1. January 7, 2025 HPC Meeting Agenda And Packet

City of Excelsior  
Notice of Special Meeting  
of the Excelsior Heritage Preservation Commission

City of Excelsior  
Special Meeting Agenda  
Excelsior Heritage Preservation Commission

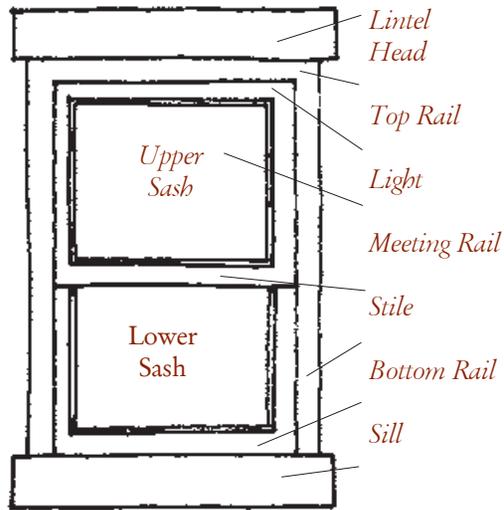
There is a question about whether there is viable wood siding under the vinyl that remains on the house. And, even if there is viable wood siding under the vinyl, requiring it to be replaced on the secondary facades would not make sense in this case given that the house already has cement fiberboard siding on its front façade. With the Manual’s clear antipathy toward vinyl siding, it may make sense to permit removal of the vinyl siding so that it can be replaced by cement fiberboard siding. If the commission finds that the value of removing the vinyl siding exceeds the potential value of finding some original wood under the vinyl siding on facades other than the front façade, it could determine that cement fiberboard should be used on the remaining facades of the house.
